RE: Jennesstown Manor Site Plan Application
Tax Map 7, Lots 39 & 39-1 – Warner

Our office is in receipt of the Aries Engineering review comments dated Oct. 20, 2025, and the Fire Department comments dated July 6, 2025. Based on the comments, we have made the required modifications and attached revised plans for review. A response to each comment has been provided below.

Aries Engineering Review Comments, dated October 20, 2025

FIRE ACCESS PLAN
JENNESSTOWN MANOR
MAP 7, LOTS 39 & 39-1
ROUTE 103
WARNER, NEW HAMPSHIRE
MERRIMACK COUNTY

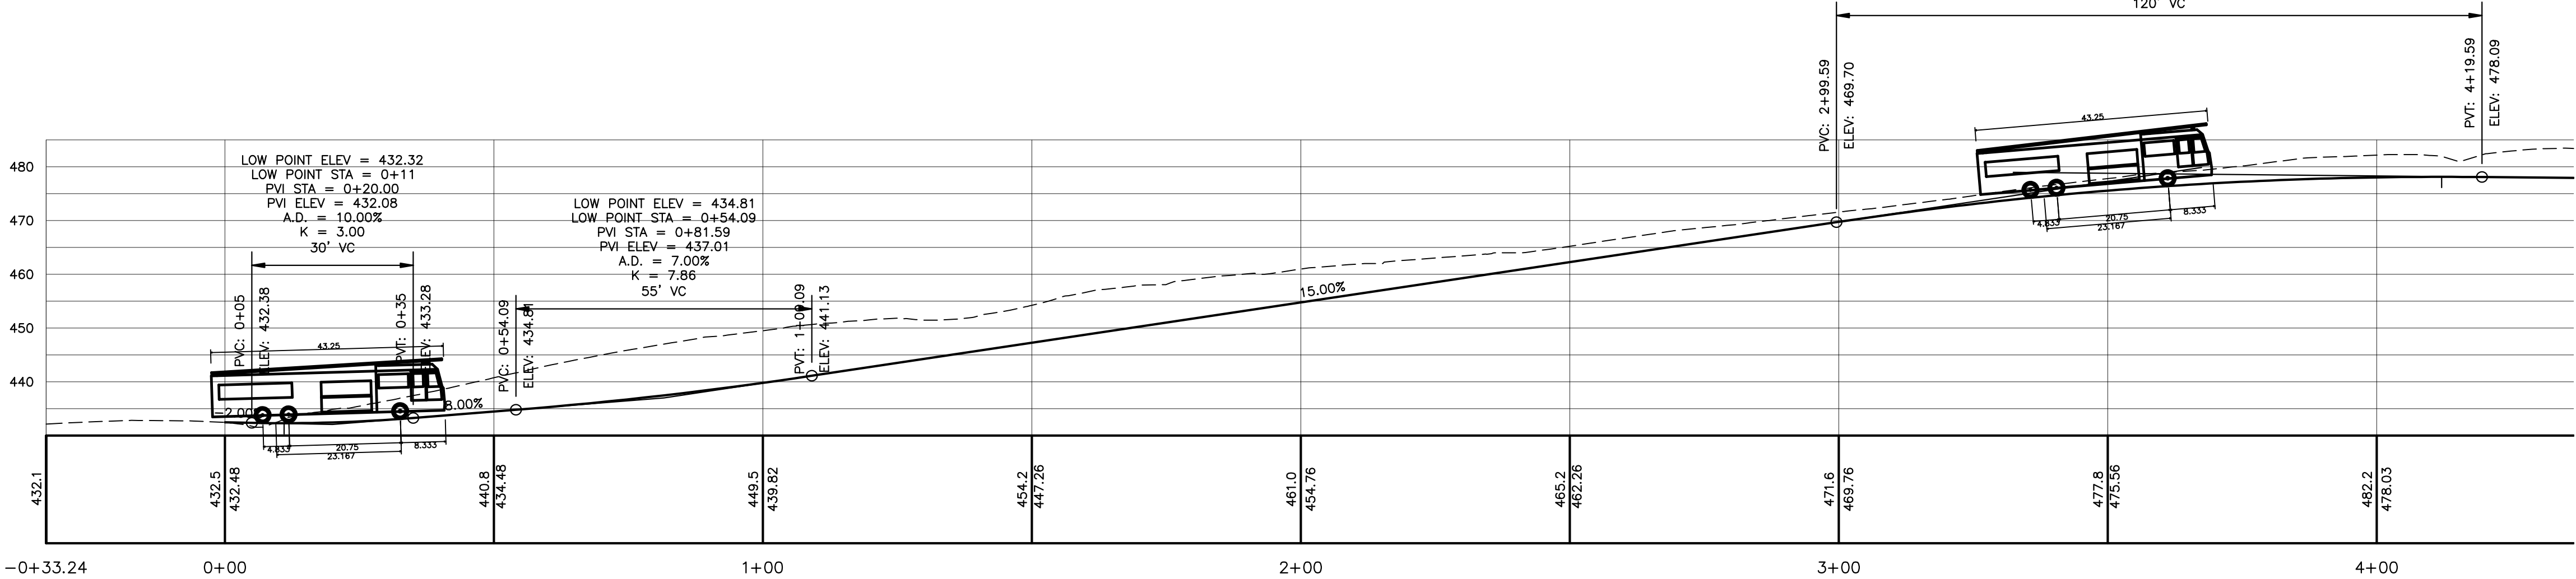
1. The State Fire Code (NFPA 1, 2021 edition, Chapter 18) requires fire department access. Please clarify the following:

- a. Show turning template for FD access on site plan. We use the 40' bus template.

A Fire Access Plan has been attached to show the turning template.

The vertical approach angle is demonstrated in the profile view on the Fire Access Plan.

- SITE PLAN
JENNESSTOWN MANOR
MAP 7, LOTS 39 & 39-I
ROUTE 103
WARNER, NEW HAMPSHIRE
MERRIMACK COUNTY

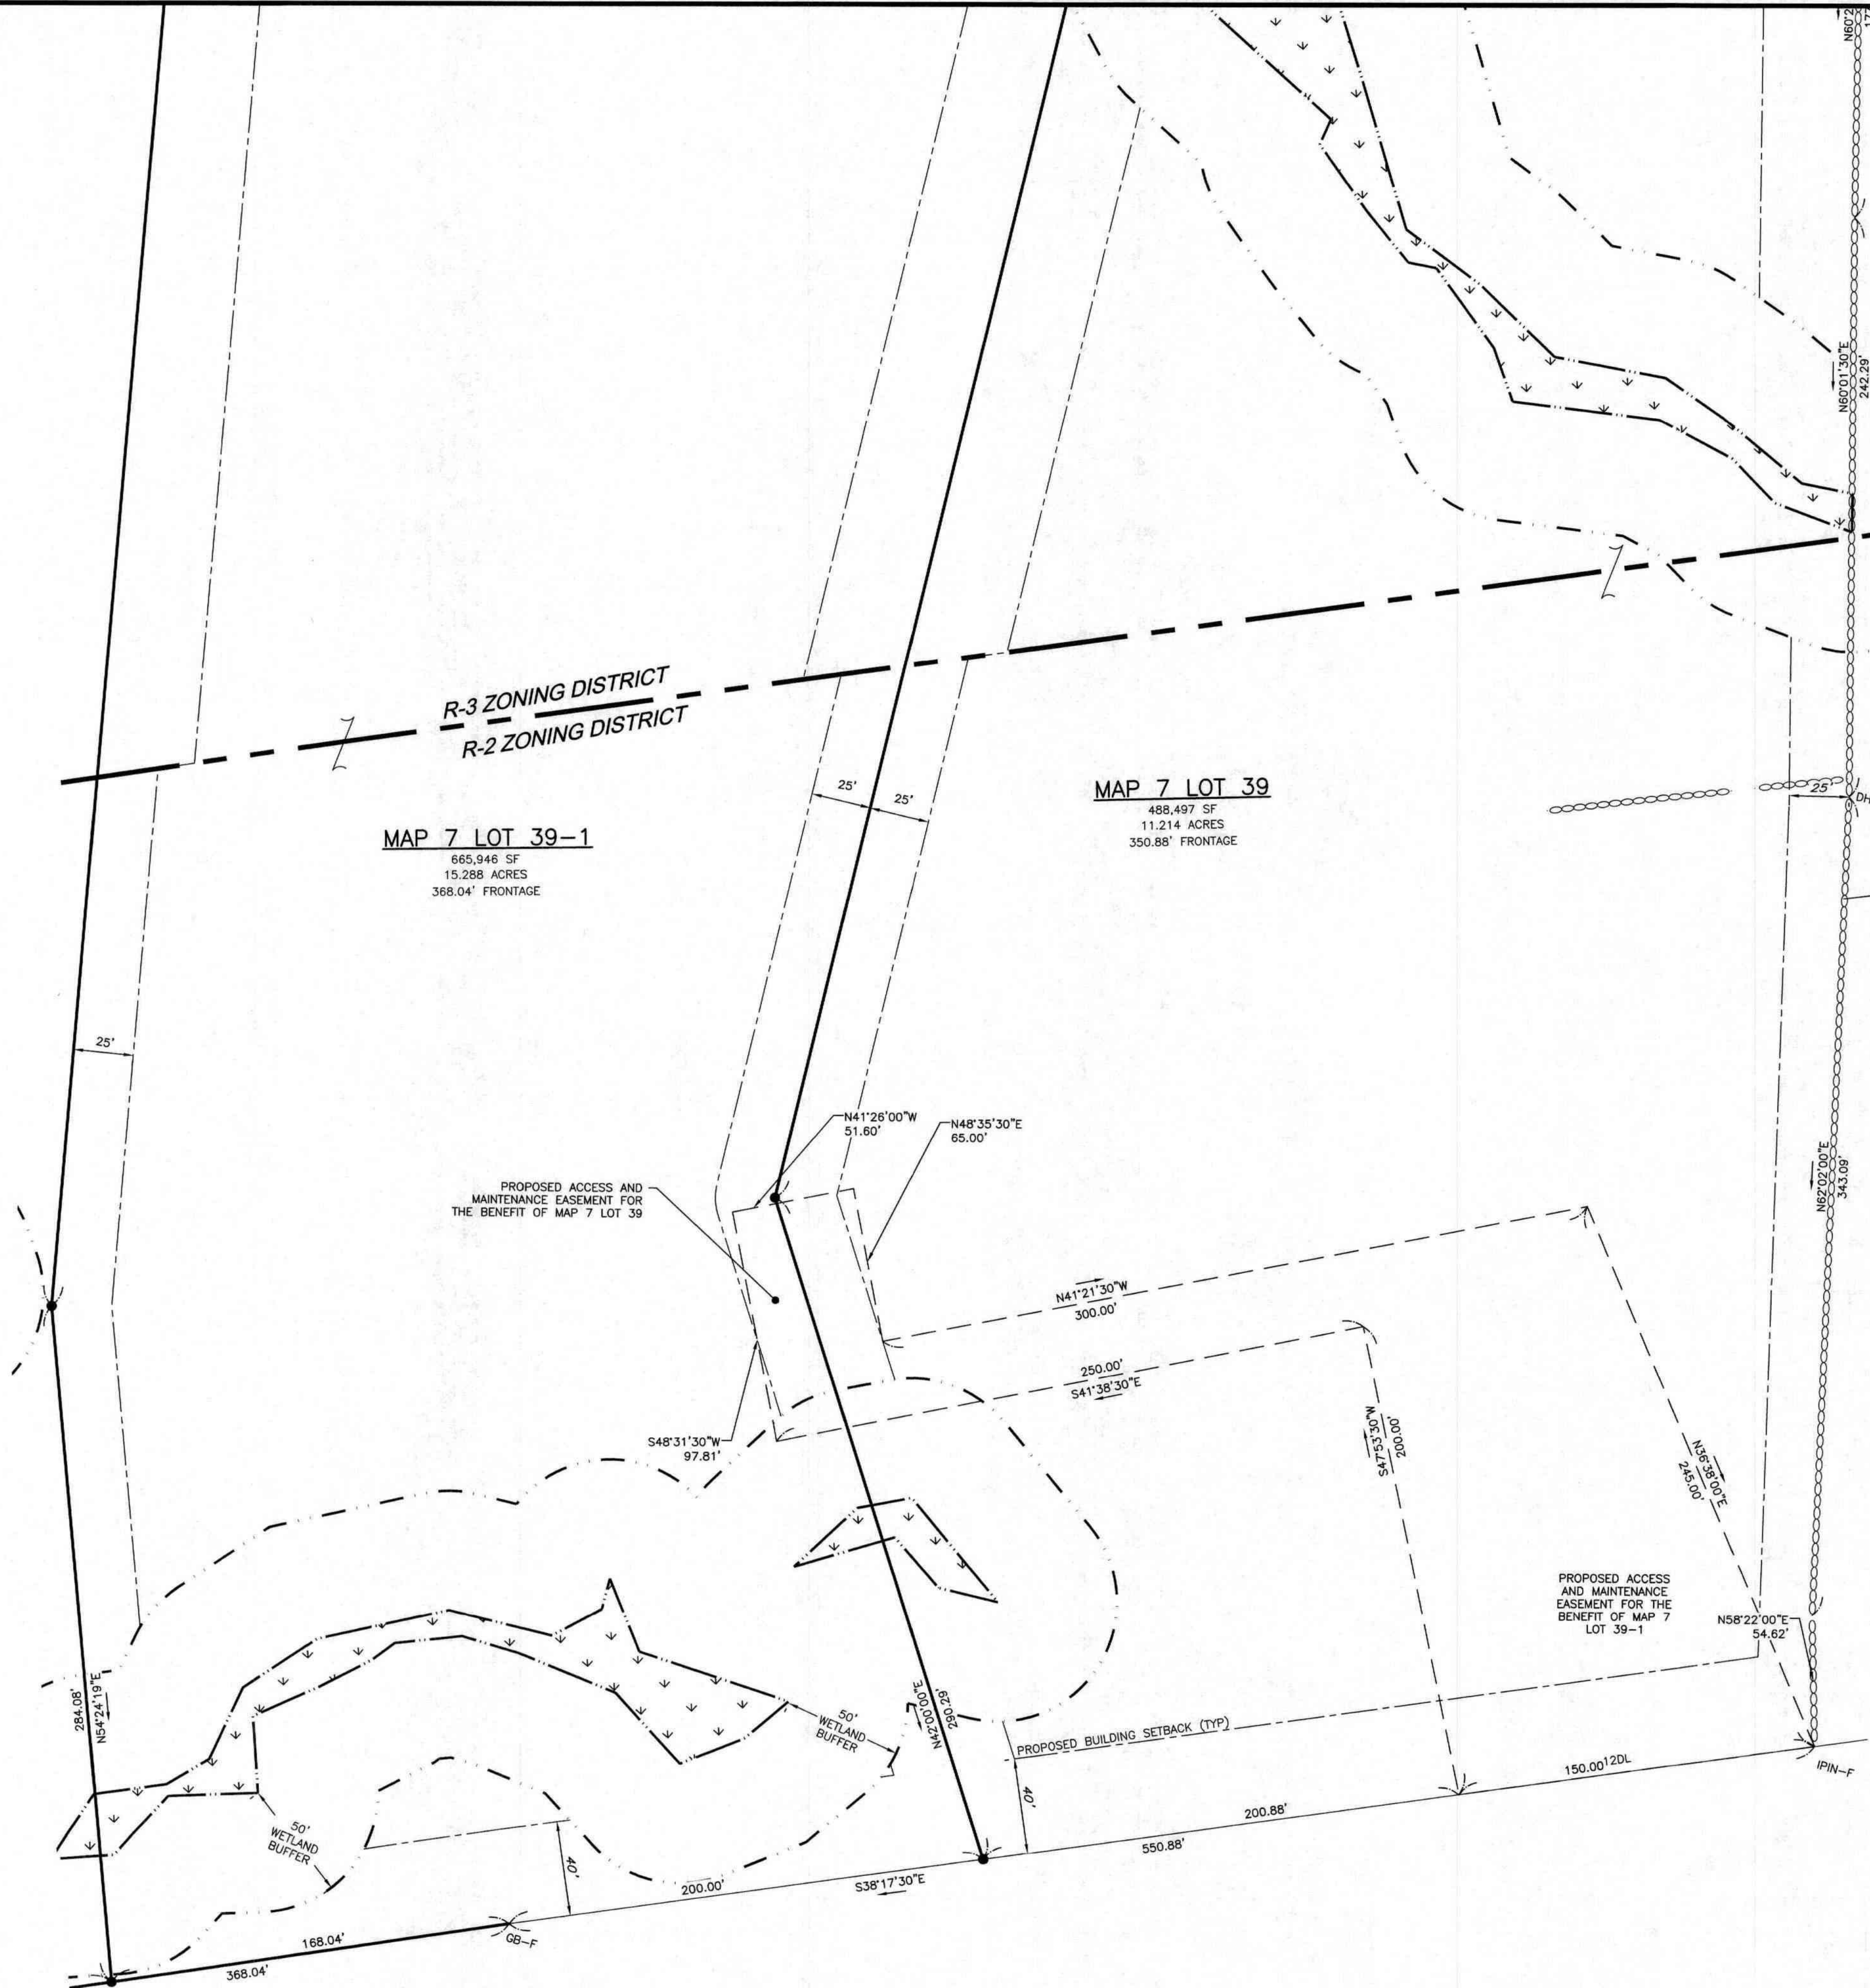
5. The site plans depict a fire truck turnaround and enclosed dumpster located approximately halfway down the proposed steep access road. Based on this location, it is presumed that fire trucks would need to back halfway down the steep access road to turn around. Aries recommends relocating the turnaround and dumpster area adjacent to and at the same level of the dwelling units where both fire apparatus will need to reverse direction and where refuse will be generated. This would provide a second fire truck turnaround.

The Site Plan currently places a fire truck turn-around between the two buildings, as seen on Sheet 3. The location mentioned in this comment is a second location. This location is also shared with the common dumpster location. The Owner/Developer desires to maintain the dumpster in the current location

EROSION CONTROL PLAN
JENNESSTOWN MANOR
MAP 7, LOTS 39 & 39-1
ROUTE 103
WARNER, NEW HAMPSHIRE
MERRIMACK COUNTY

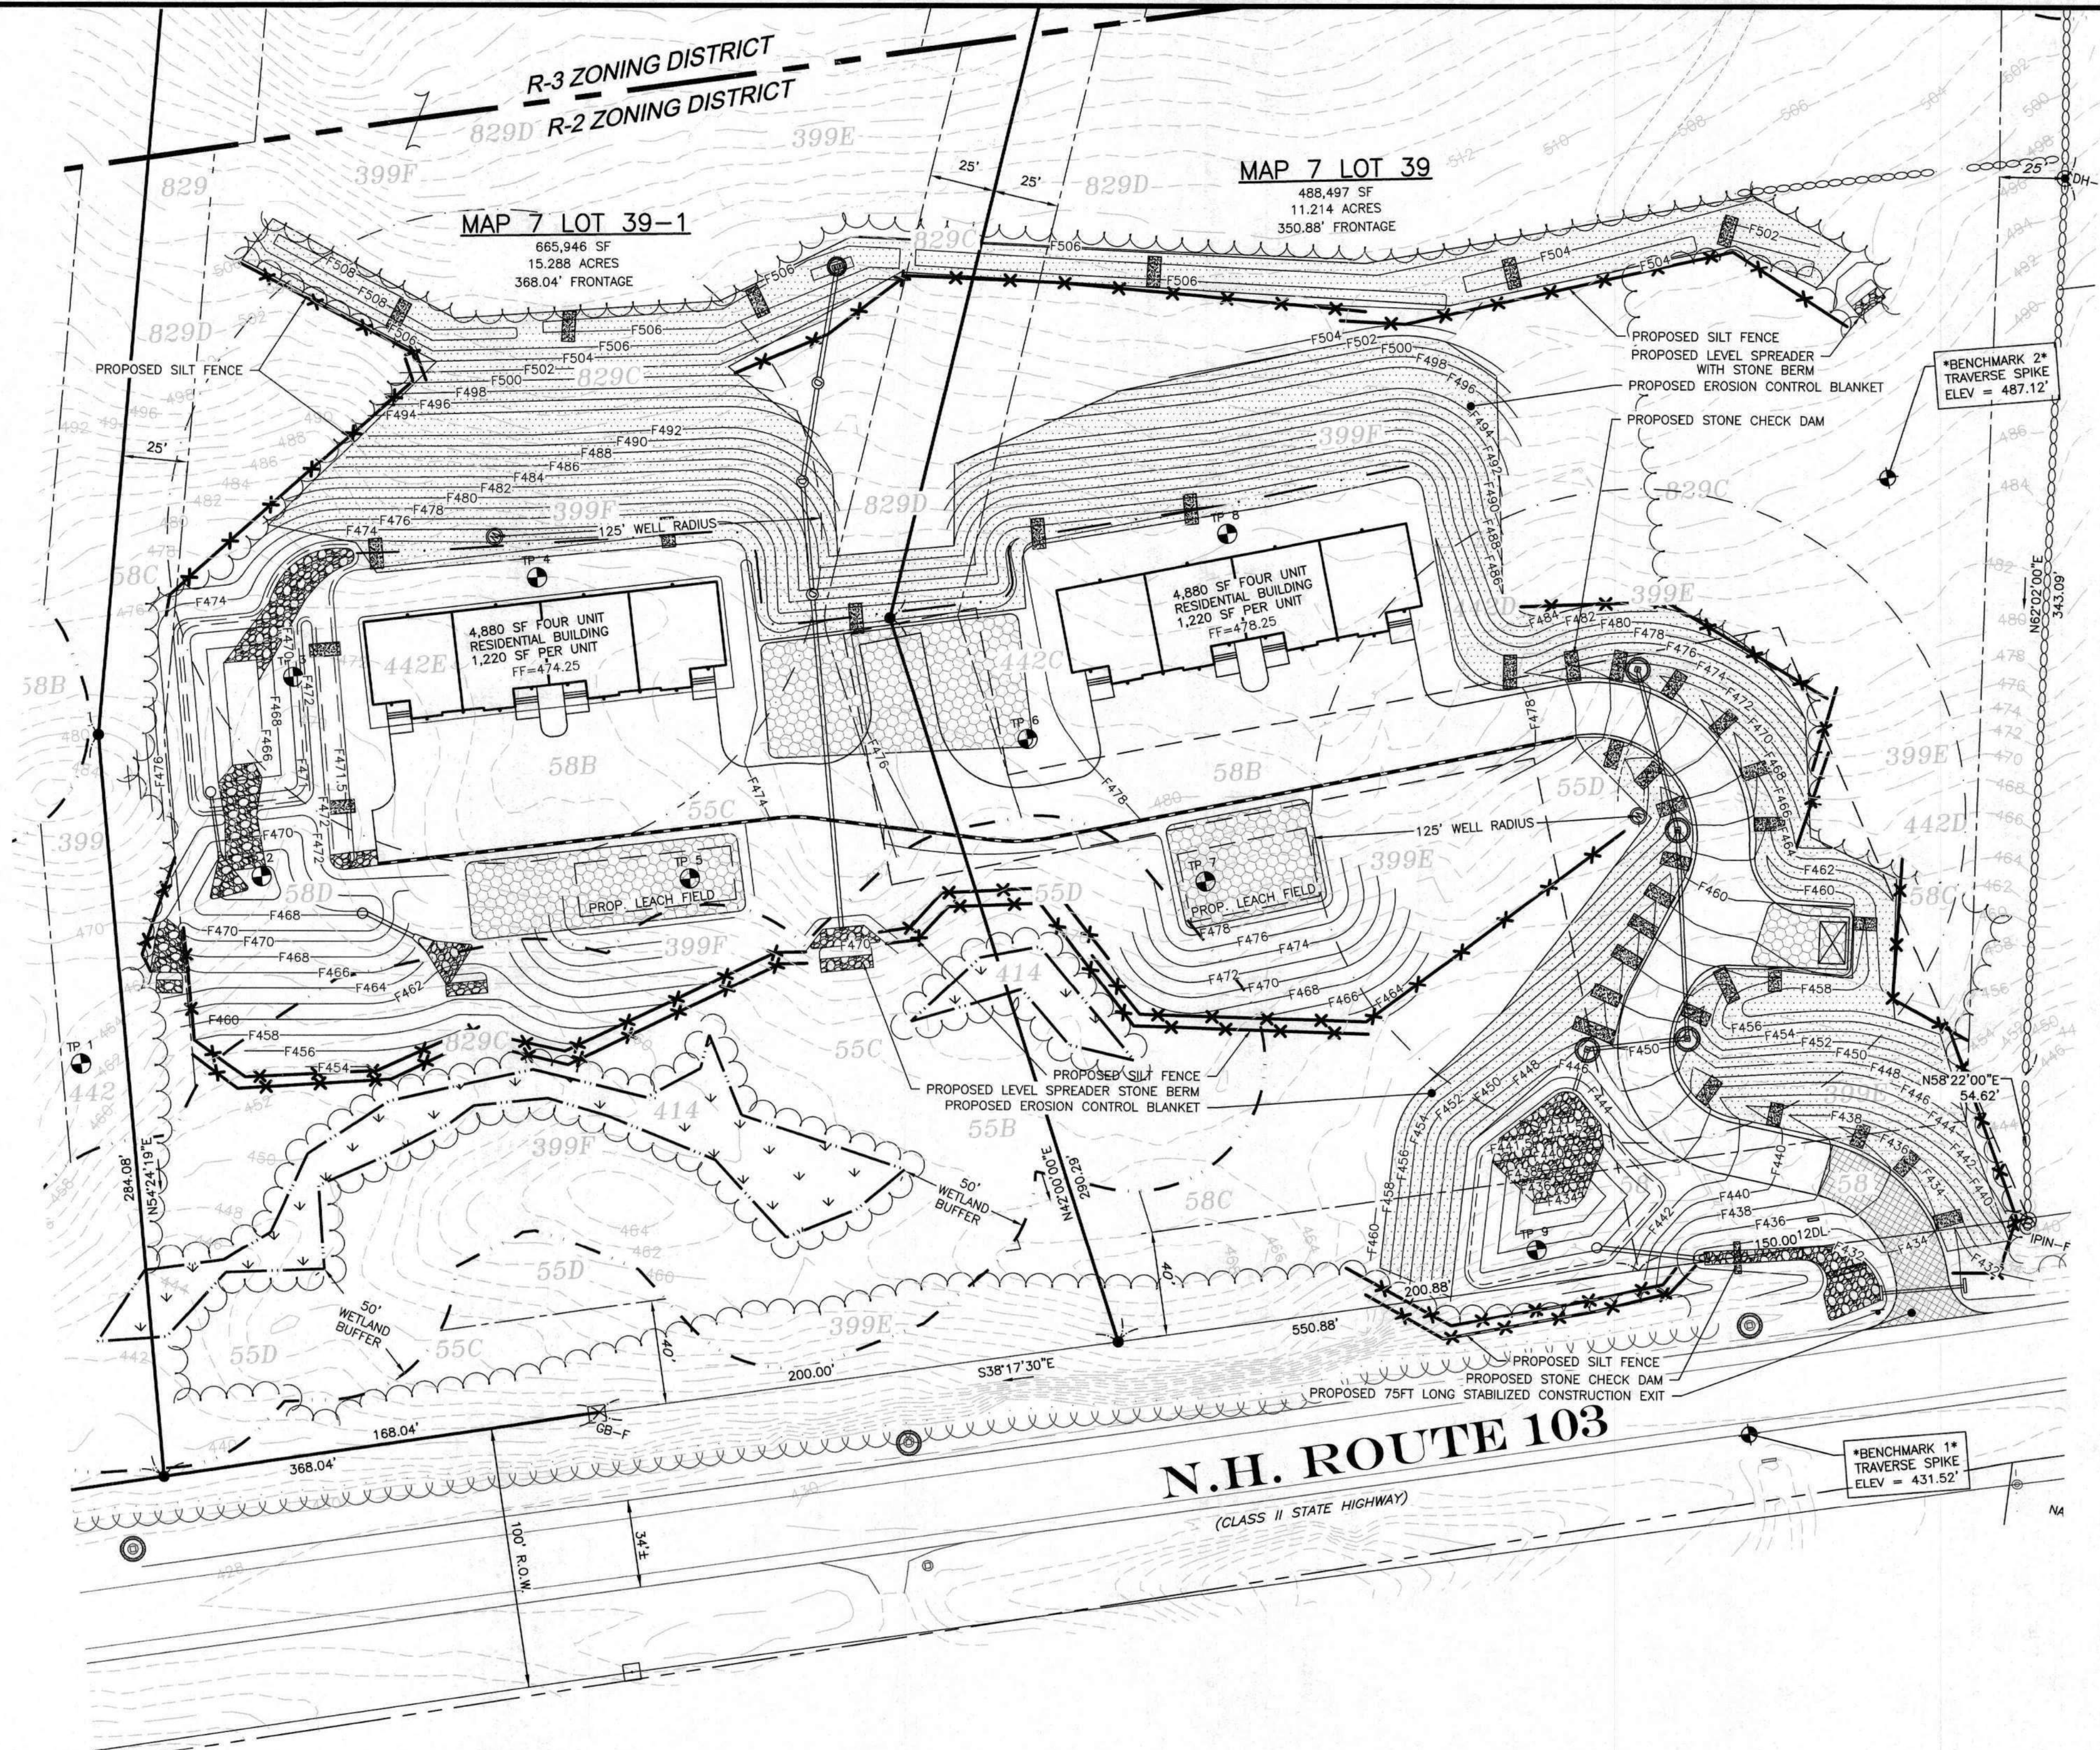
27. Erosion Control notes are provided in the site plan construction details. Aries recommends that the Town conduct periodic inspections to ensure that specified erosion control procedures are followed.

Note 10 on Sheet 6 provides the Town oversight on the placement and function of the erosion control.
